Rockingham Phase 2A – Proposed Commercial Development Reserved Matters
Application Ref: 2021/1007
Response to Comments Made by BMBC Highways dated 9th November 2021
Initial Issue – 29th November 2021
Our Ref: 21095/MOS/TS.

This brief Transport Statement has been prepared to provide a response to the enclosed comments made by BMBC highways following consultation of the Reserved Matters application at Rockingham Phase 2A in support of commercial development.

JUNCTION INTER-VISIBILITY AND SPACING
2.4m x 43m SPLAYS SHOWN

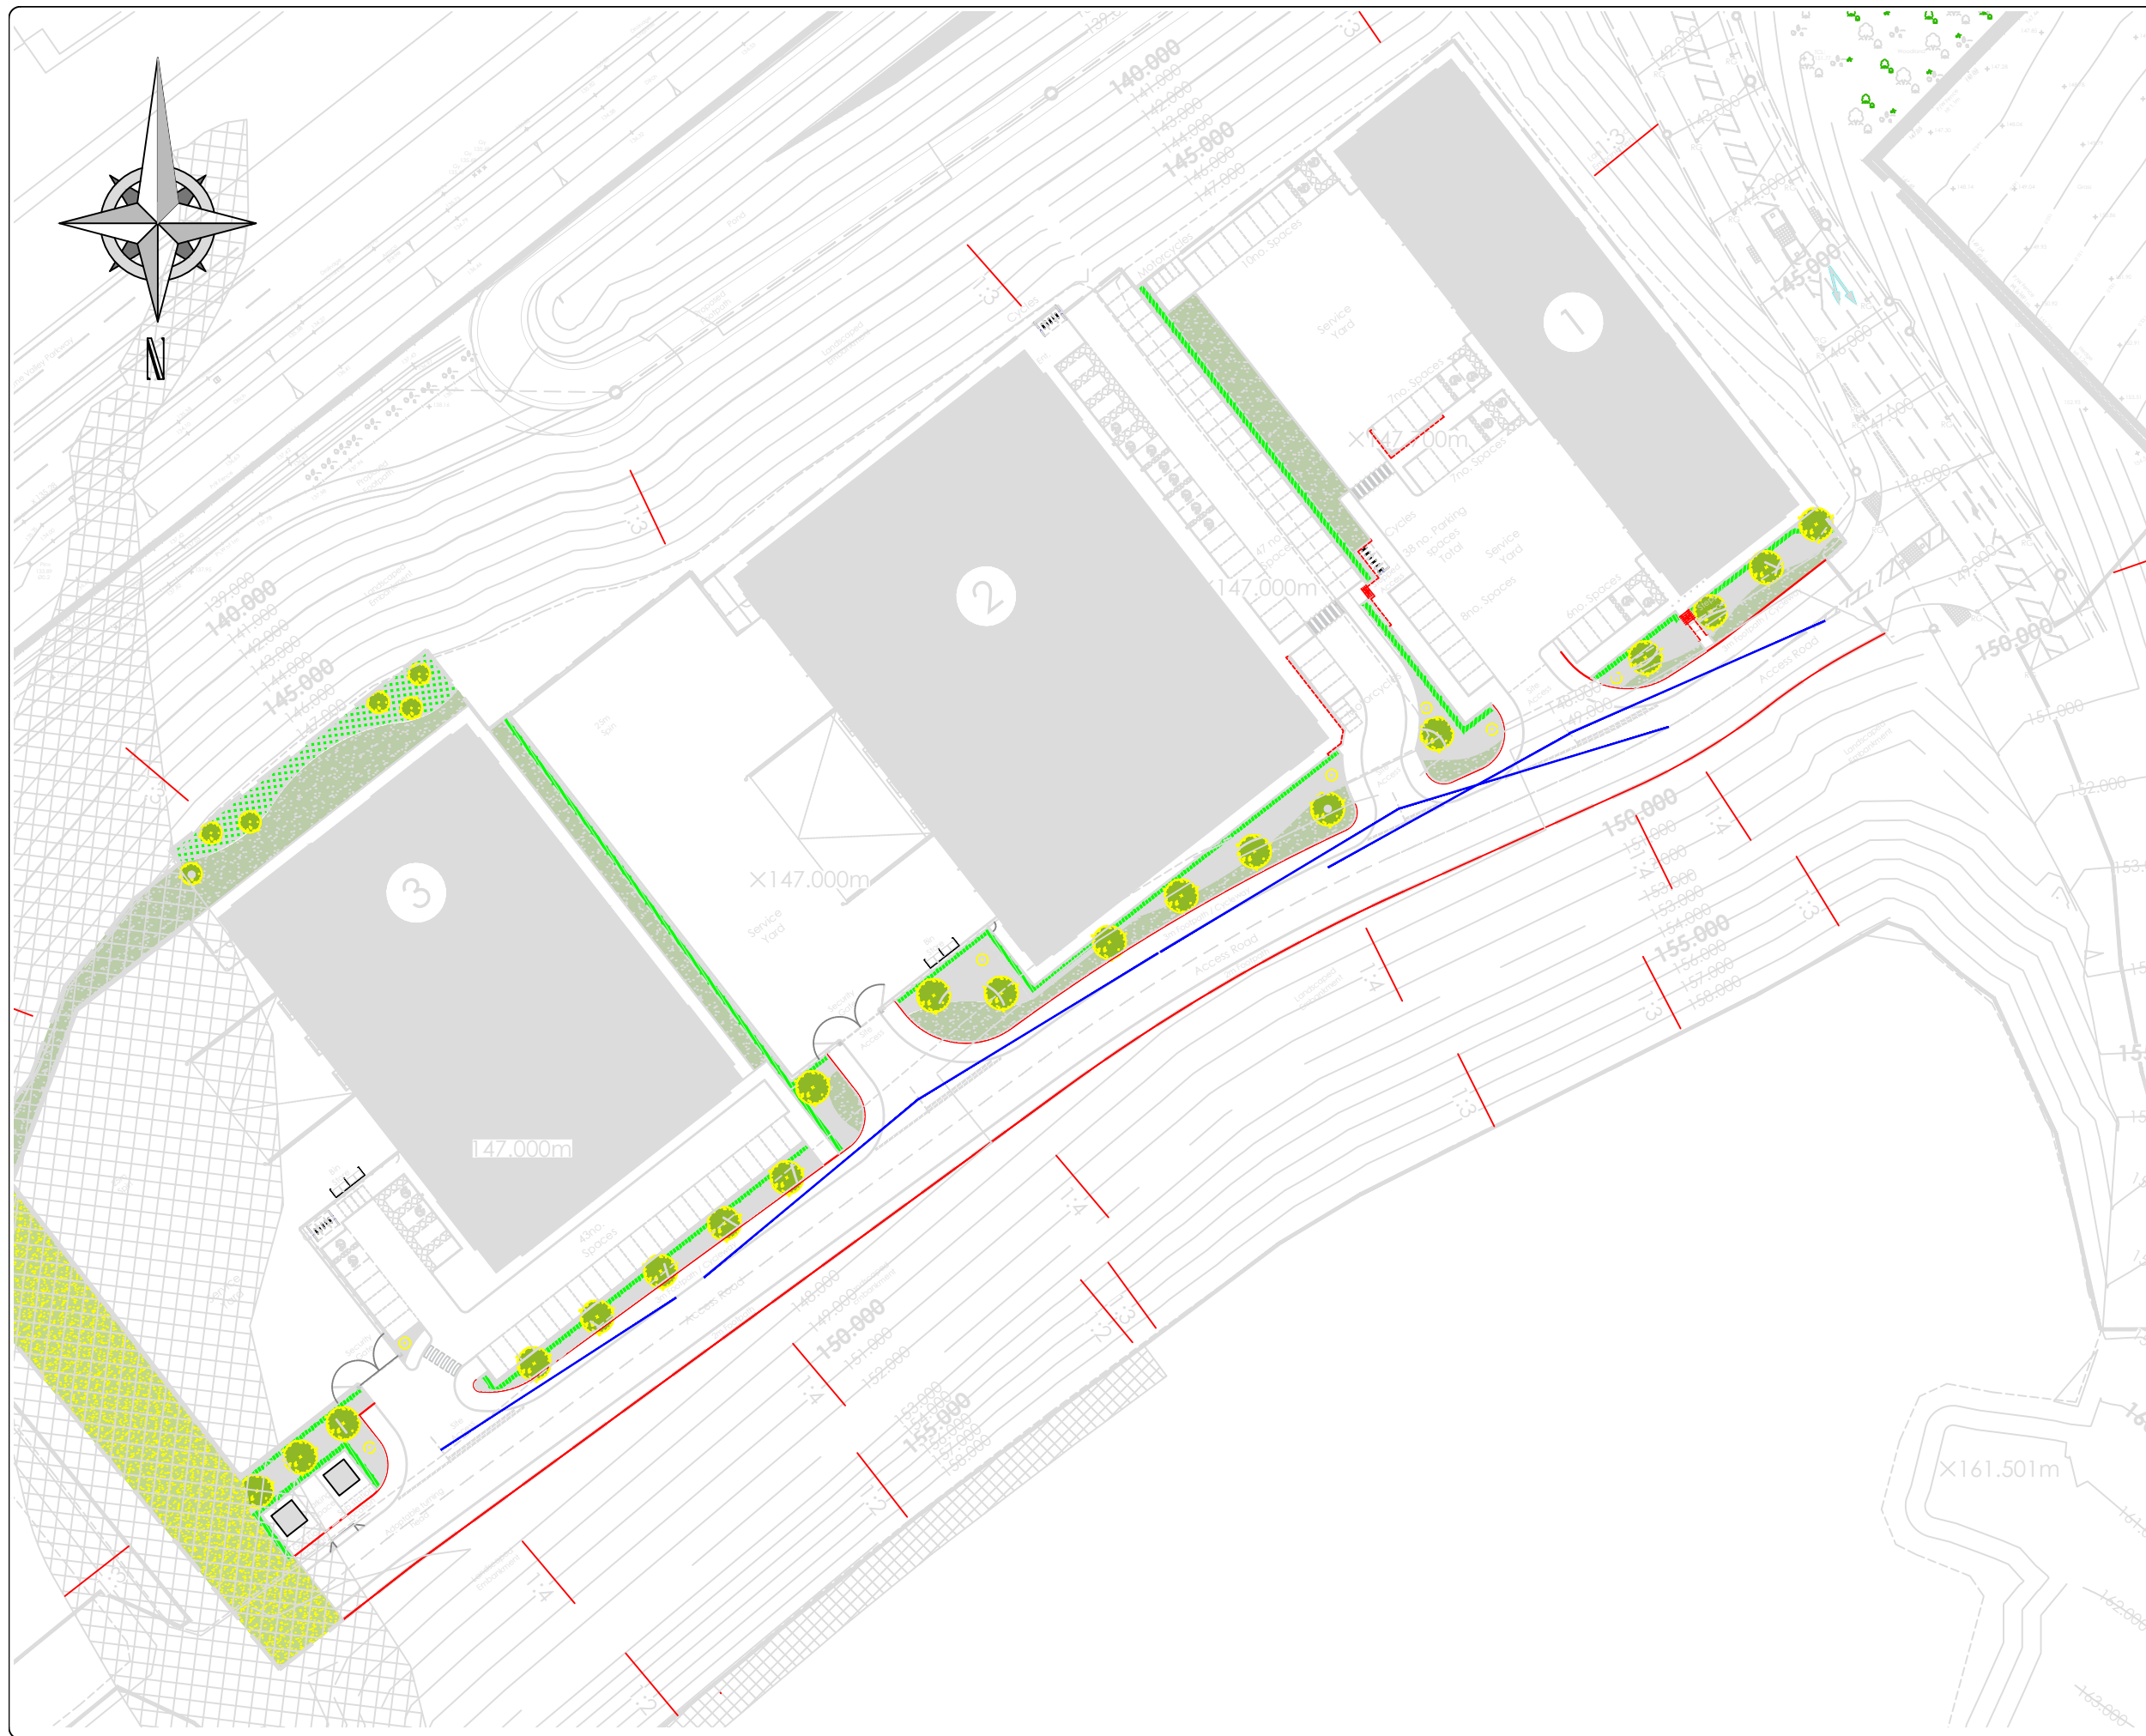
The officer states that junction spacing must be such that it ensures that vehicles do not impede visibility from either access. It is assumed that this means that a vehicle waiting to exit one of the junctions should not block the visibility of a vehicle exiting the other junction.

However it is unclear what design standards have been adhered to for the access road and clarification is sought on this point. Separation of the main site access for units 1A-1D and car park for unit 2 is only 30metres and does not accord with standards that I am aware of. Separation is required to accord with the “Y” distance of the visibility splays to ensure vehicles do not impede visibility from either access. Please review and amend as appropriate. Furthermore longitudinal gradient for the access road needs to be clarified by the applicant (absolute max 1:12) and confirmation that the requisite visibility splays can be achieved in the horizontal and vertical plane. The splays are to be shown on plan.

Notwithstanding this, Mosodi have prepared the enclosed drawing No. 21095.IN.01 that shows clearly that each junction does not impede visibility from the other. The enclosed drawing shows the following:

- When looking left from the car park access to the lane accommodating oncoming traffic that vehicles waiting to exit do not impede visibility. There is a splitter island that would prevent vehicles being on the wrong side of the road;
- When looking right from the Unit 1 access the splay when measured to a 1.0 off set from the channel line i.e. where the position of the nearside of a vehicle. It is clear that a vehicle would not impede visibility.
